**RE: 15602 Benedict Lane**

I reviewed the drawings and evaluated the site context. My comments and recommendations are as follows:

*Proposed Front Elevation*

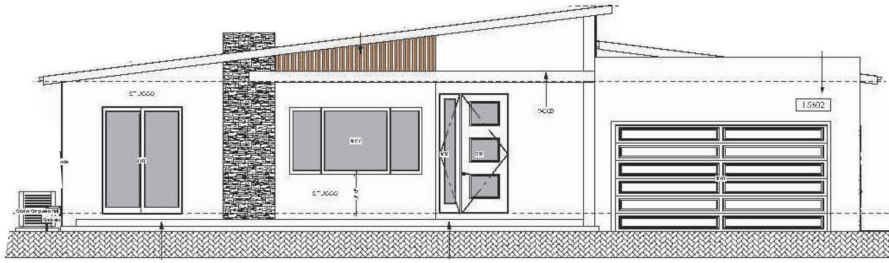
The proposed home is designed in a traditional Eichler-like architectural style - see proposed elevations below.

- The front elevation is quite monumental in scale for the proposed architectural style. The recessed entry is approximately 11'-6" in height with an entry door of over 9 feet, and the flat-roofed garage is almost 14 feet in height .

- Stone and wood siding is proposed on the front elevation without carrying those materials consistently around to all other elevations which is not consistent with *Residential Design Guideline 3.2.2*.

1. Lower the height of the entry and roof eaves to bring the design more into scale with its human occupants and the proposed architectural style.
2. Reevaluate all window types and proportions to be consistent with the proposed architectural style.
3. Add trim to all windows.
4. Increase all roof overhangs.
5. Consider adding translucent windows adjacent to the entry door.
6. If additional wall materials such as stone or wood siding are proposed on the front elevation, carry those materials consistently around all sides of the house.

*Proposed Streetscape*

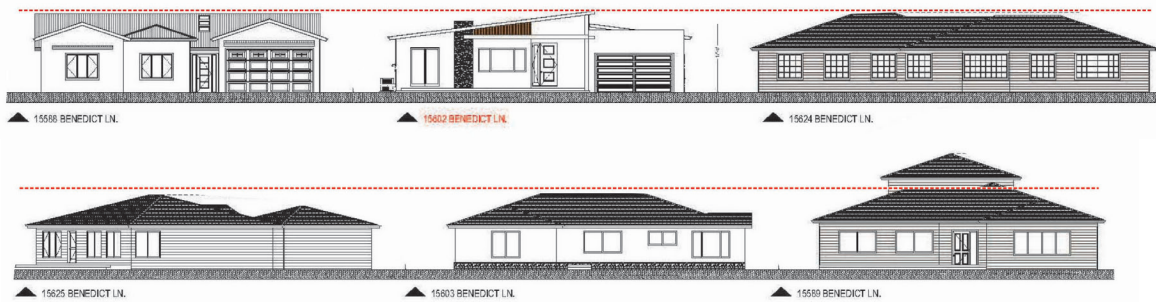
The proposed one-story house would be consistent with the scale and overall building height of the immediate neighborhood - see comparative streetscale illustrations below.

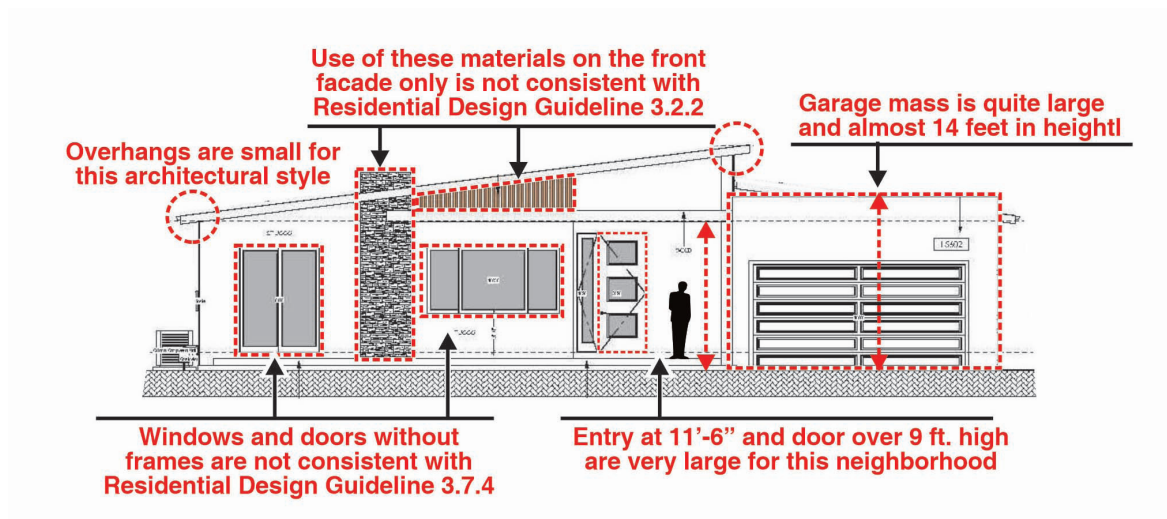
1. The proposed architectural style is heavily influenced by and is a somewhat stripped down version of a typical low-sloped roof Eichler Home of the 1960s. Normally one sees issues with new homes blending into an older Eichler neighborhood rather than designing an Eichler-like home for a traditional Ranch Style neighborhood with a preponderance of hip roofs. The proposed house design would not be consistent with *Residential Design Guideline 3.2.1*

**Architectural style, roof forms and roof slopes are quite a departure from other homes in the immediate neighborhood and not consistent with Residential Design Guideline 3.2.1**

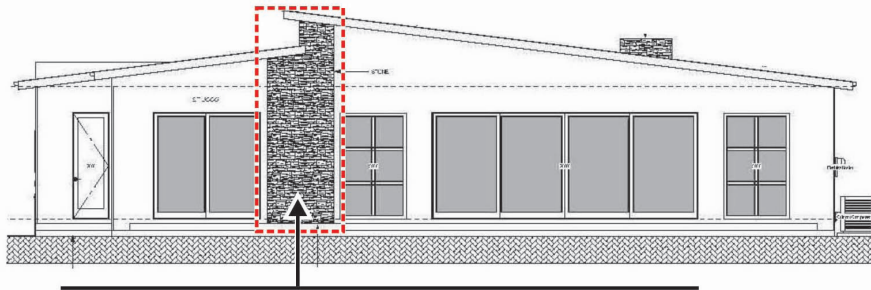
- Windows and doors without trim are not consistent with *Residential Design Guideline 3.7.4*.

**A change of material in the same plane as the stucco is not consistent with Residential Design Guideline 3.8.4**

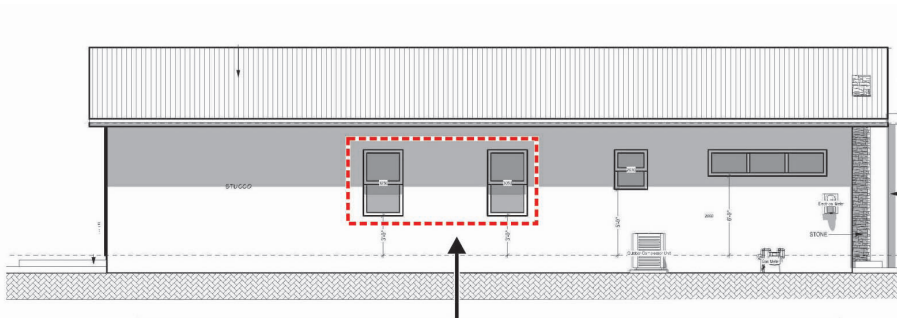
6. The change of materials in the same plane on the rear elevation would not be consistent with *Residential Design Guideline 3.8.4*.
